PROJECT TITLE: Grading & Drainage Plan
Sonic Drive-In ZONE ATLAS/DRNG. FILE #: K-11/D47
LEGAL DESCRIPTION: North Portion of Tract 67, Unit 6, Town of Atrisco Grant
CITY ADDRESS: 6420 Central Avenue, West

GRADING AND DRAINAGE PLAN
SONIC DRIVE-IN RESTAURANT
6420 Central Avenue west .
Albuquerque, New Mexico

RE: REVISED DRAINAGE PLAN FOR SONIC DRIVE-IN
6420 CENTRL AVENUE, NW (K-11/D47
REVISION DAATED APRIL 27, 1988

RE: DRAINAGE PLAN FOR SONIC DRIVE-IN
6420 CENTRAL AVENUE, NW (K-11/D47)
RECEIVED APRIL 18, 1988

GRADING AND DRAINAGE PLAN
SONIC DRIVE-IN
6420 CENTRAL AVENUE WEST

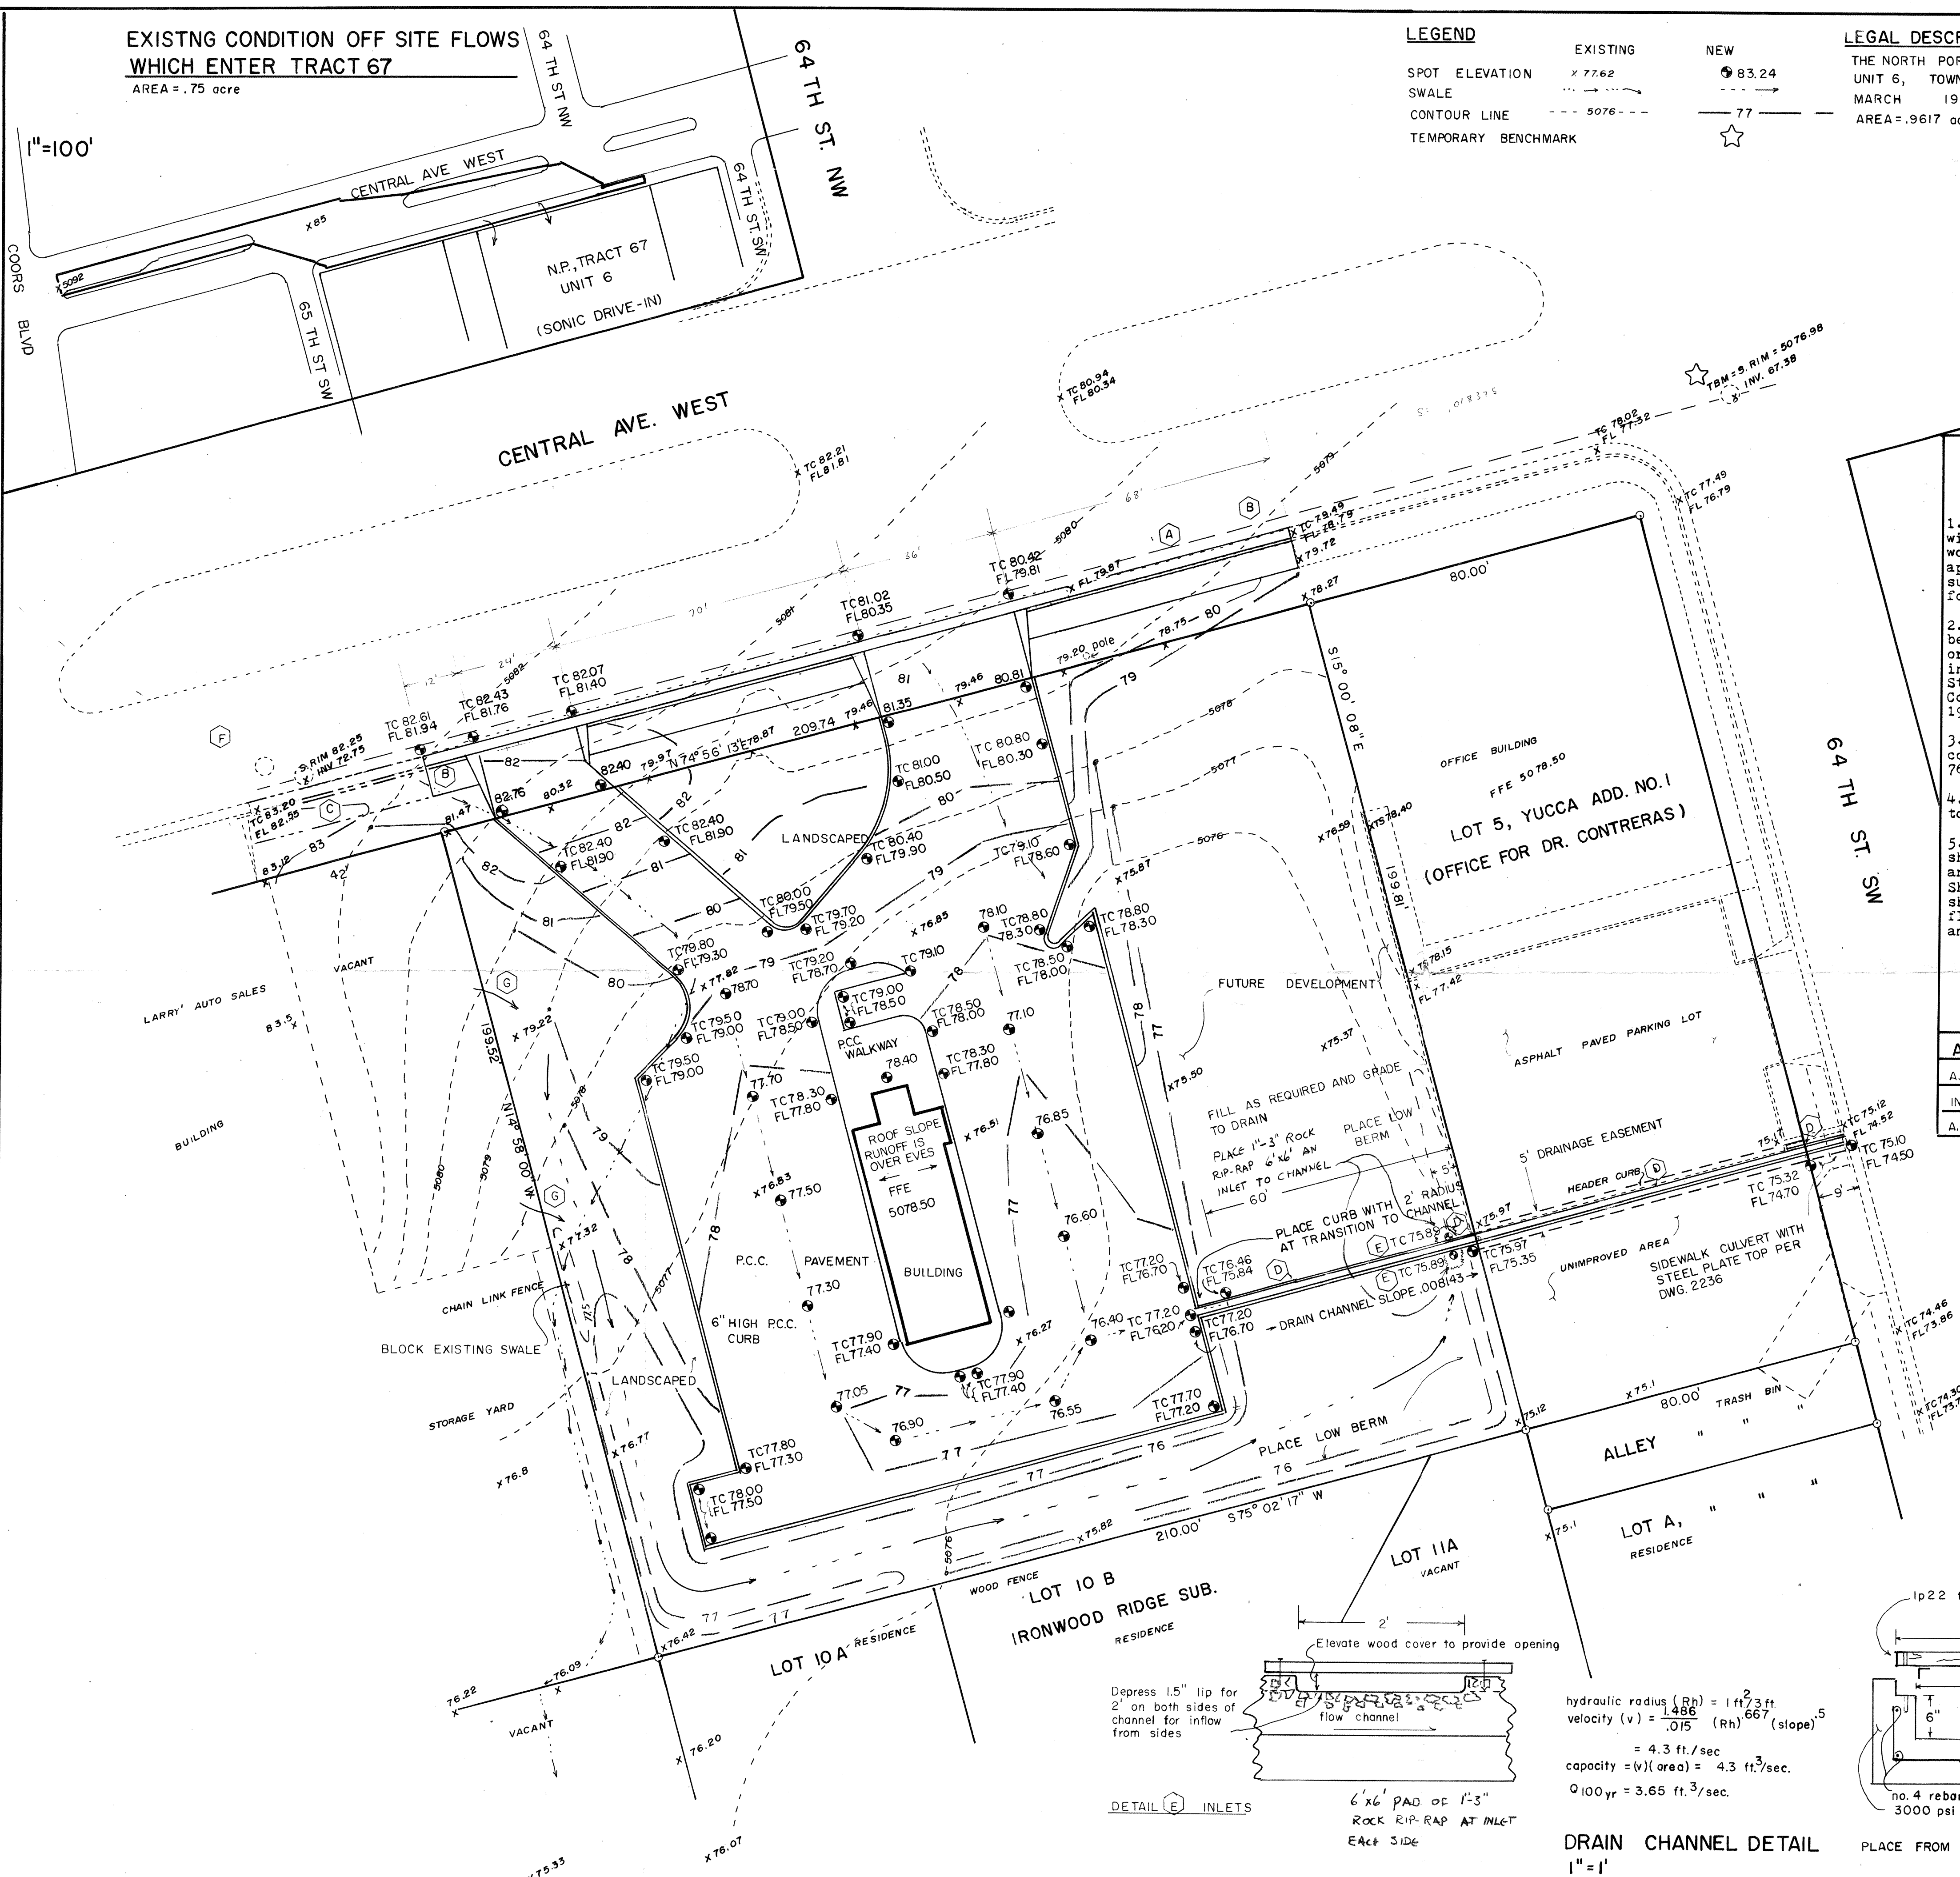
Based on the information provided on your submittal of April 18, 1988, listed are some concerns that will need to be addressed prior to final approval:

1. Location and direction of roof drains.
2. Off-site flows from the west must be accepted and routed around towards the proposed channel.
3. Flows from the northeast corner of Tract 67 cannot be ponded, they also must be routed into the channel.
4. You will need to include the "Notes" portion of the S.O. #19 format along with the sign-off blocks on your plan drawing (two copies required with resubmittal).
5. Drainage Easement, copy shows 80,000 ft. instead of 80.00 ft., please change and provide a copy with resubmittal.

6. Note on plan identifying that no public runoff is to enter the site.

This letter is in reply to comments provided in your letter of April 25, 1988 on the above subject. Below are responses to your letter.

1. The roof runoff is now indicated.
2. A note and clarification are now shown on the drawings indicating that off-site flows from the west will be accepted and routed towards the proposed channel.
3. Flows from the undeveloped northeast corner of the tract are now clearly indicated to flow into the new concrete channel.
4. The notes portion and signature blocks from S. O. #19 are now included on the drawings. Two copies of the drawings are included with this submittal.
5. The typographical error on the easement is in the process of being corrected. The original of the easement is in Las Cruces, and will be returned, resigned and re-recorded. You will be provided a copy of the corrected easement.
6. A note is now on the plans identifying that no public runoff is to enter the site.

- (A) REMOVE EXISTING DETERIORATED STD. CURB & GUTTER (55')
- (B) PLACE NEW C & G, DRIVEPADS, AND SIDEWALKS BY SEPARATE PERMIT
- (C) PLACE BERM AND TEMPORARY C & G TO CHANNEL STREET RUNOFF TO NEW C & G
- (D) PLACE .5" EXPANSION JOINT AT 64TH ST R.O.W., AND AT 40' INTERVALS
- (E) INLETS, SEE-DETAIL
- (F) NO RUNOFF FROM PUBLIC R.O.W. IS TO ENTER THE SITE
- (G) RUNOFF FROM LOT TO WEST IS TO BE ACCEPTED AND DISCHARGED TO 64TH ST.
